ALERT SERVICE BULLETIN

SUBJECT: OPTIONAL EQUIPMENT - Outboard Load System - Introduction of life limit, a first time and repetitive inspection and replacement of quick release pin bolts

Revision No.	Date of issue
Revision 0	2017-07-24
Revision 1	2017-12-19

Check of performed hoist cycles
 Figure 1

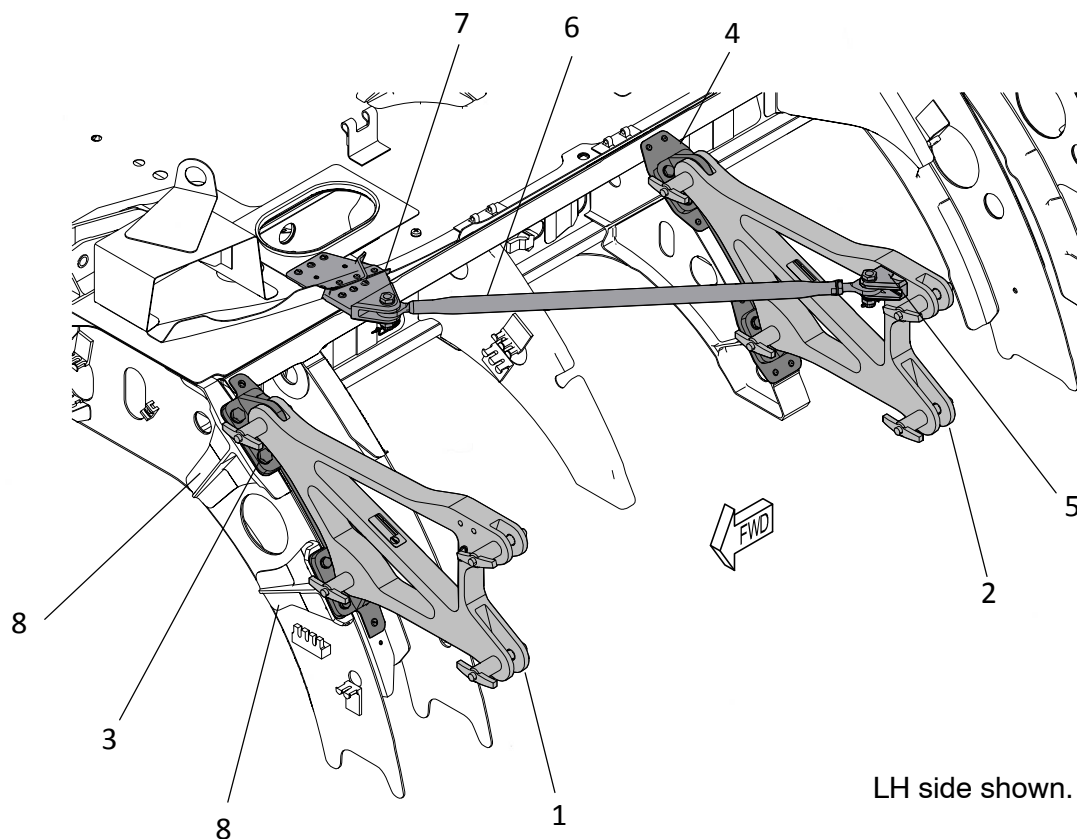
- Record the performed hoist cycles or new basic hoist cycles in the maintenance schedule. The record of the hoist cycles must be continued.
For the affected parts / components refer to Table 1 and Figure 1.

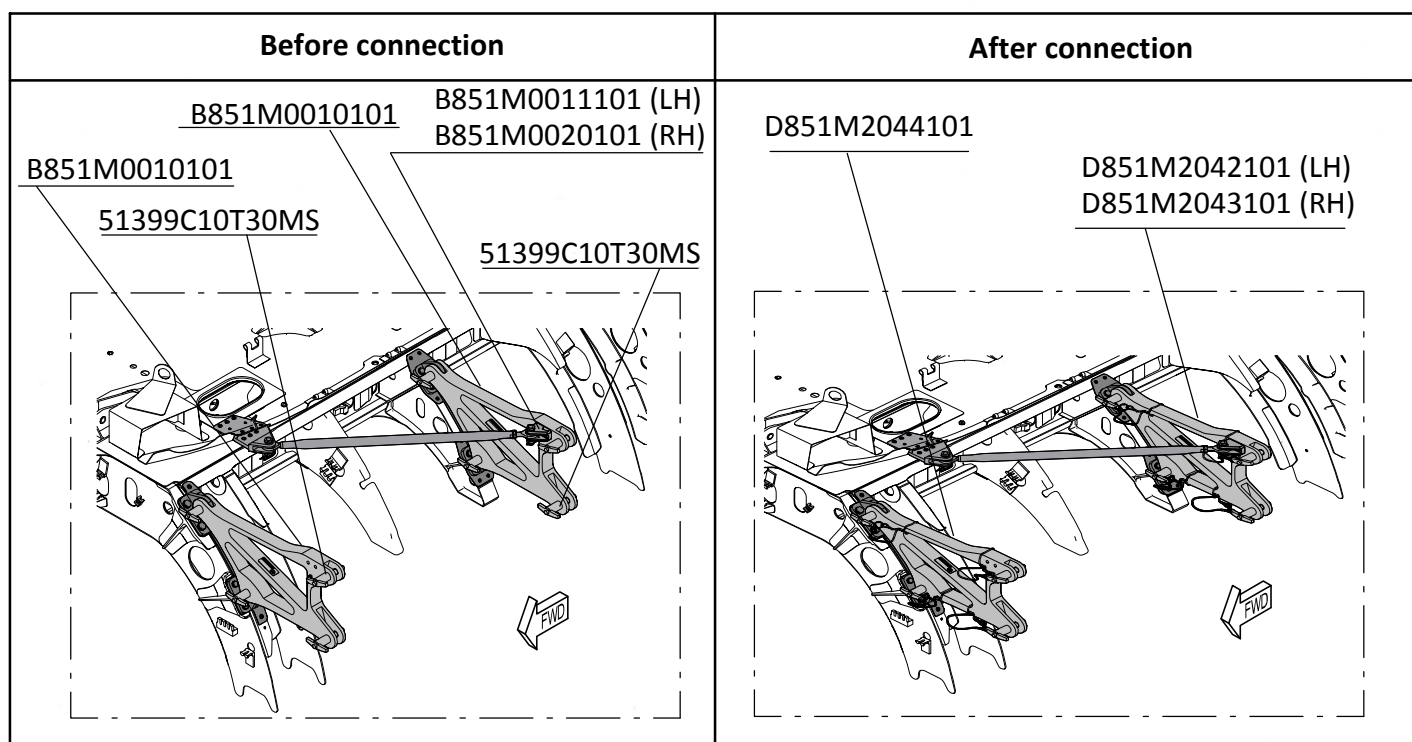
1. Check of the fitting FWD (1, Fig. 2) and fitting AFT (2):
 - a. Clean the fitting FWD (1) and fitting AFT (2).
 - b. Check the fitting FWD (1) and fitting AFT (2) for cracks and damage using a flashlight and a magnifying glass. If cracks or damage is detected contact AHD customer support before the next flight with an outboard load system.
2. Tightening check of the bolts (3, 4):
 - a. Clean the heads of the bolts (3, 4).
 - b. Apply a tightening torque of **6 Nm** to the bolts (3, 4) to check tight fit. Refer to Figure 2.
 - c. If the bolts are turning, tighten the bolted connections (bolt / nut) with a tightening torque i.a.w. Section 3.B.8 step 2.b.

Connection of quick release pin bolts
 Figure 3

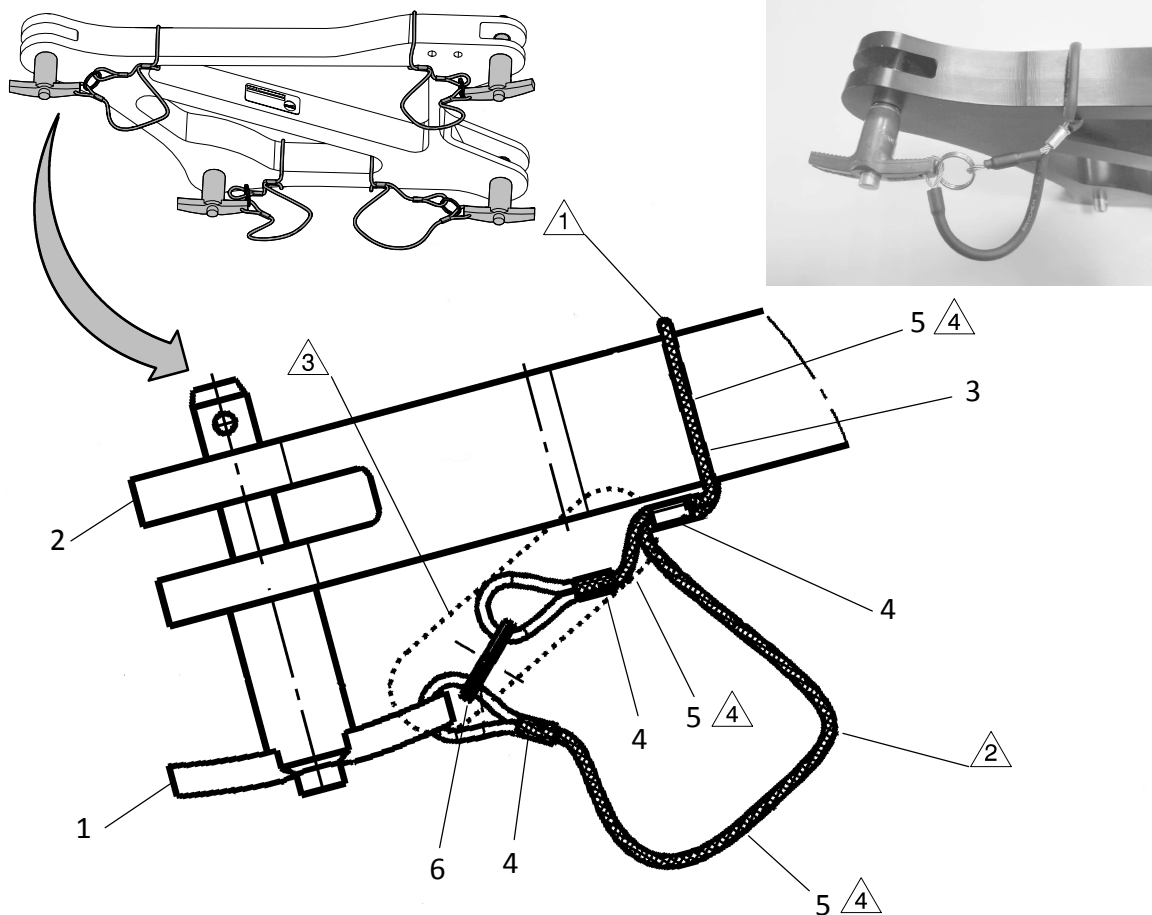
1. Cut the wire rope from the material kit in four equal parts.
2. Thread the wire rope (3, Fig. 3) into the quick release pin bolt (1) and press the clamp (4).
3. Slide the heat shrinkable sleeve (5, Fig. 3) onto the wire rope (3).

4. Thread the wire rope (3, Fig. 3) through the adapter (2), press the clamps (4) and install the ring (6). For details refer to , , .
5. Shrink the heat shrinkable sleeve (5, Fig. 3). For details refer to .

- △1 Install clew as near and tight as possible to quick release pin bolt.
- △2 Adjust clew length so that the quick release pin bolt is easy to remove.
- △3 In marked area install cable as short as possible. Maximum way for quick release pin bolt 14 mm.
- △4 Install and shrink heat shrinkable sleeve (3 parts) in the shaded area.

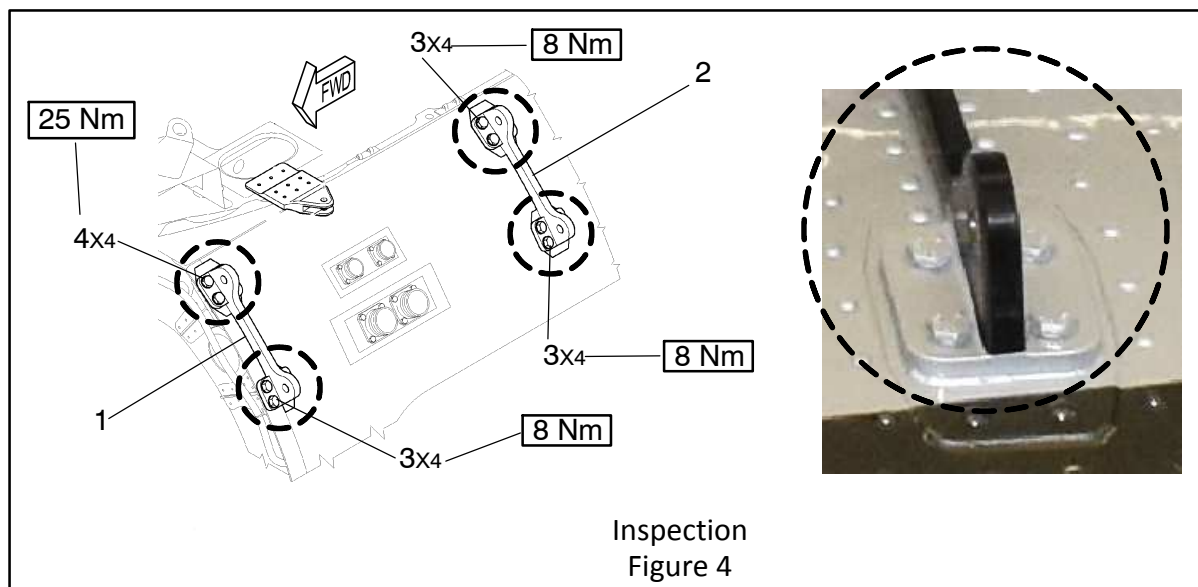
1. Check of the fitting FWD (1, Fig. 4) and fitting AFT (2):
 - a. Clean the fitting FWD (1) and fitting AFT (2).
 - b. Check the fitting FWD (1) and fitting AFT (2) for cracks and damage using a flashlight and a magnifying glass. If cracks or damage is detected contact AHD customer support before the next flight with an outboard load system.
2. Tightening check of the bolts (3, 4, Figure 4):
 - a. Clean the heads of the bolts (3, 4).
 - b. Apply a tightening torque of the bolts (3, 4) to check tight fit. Refer to Figure 4.

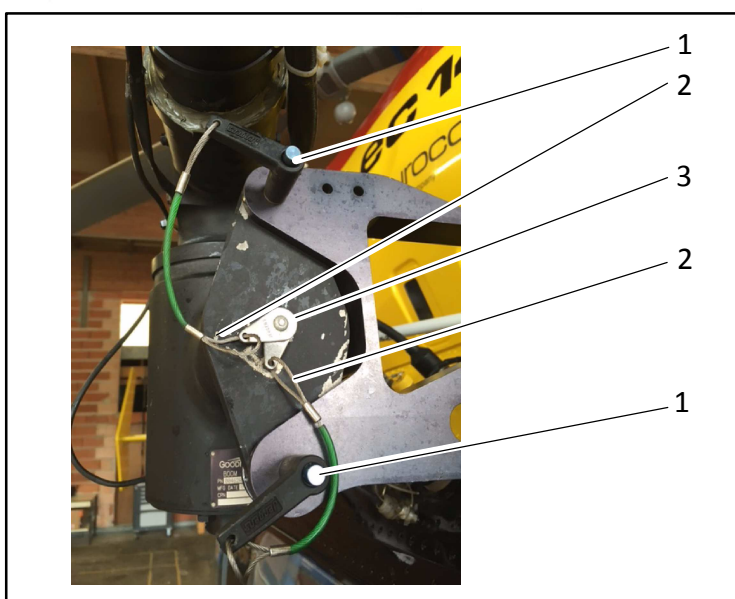
NOTE The lashes (3) on the mounting brackets of the Goodrich support assembly must not be removed.

If quick release pin bolts (1) are attached to the mounting bracket of the Goodrich support assembly, cut the wire ropes (2) and remove them together with the quick release pin bolts (1) and discard them.
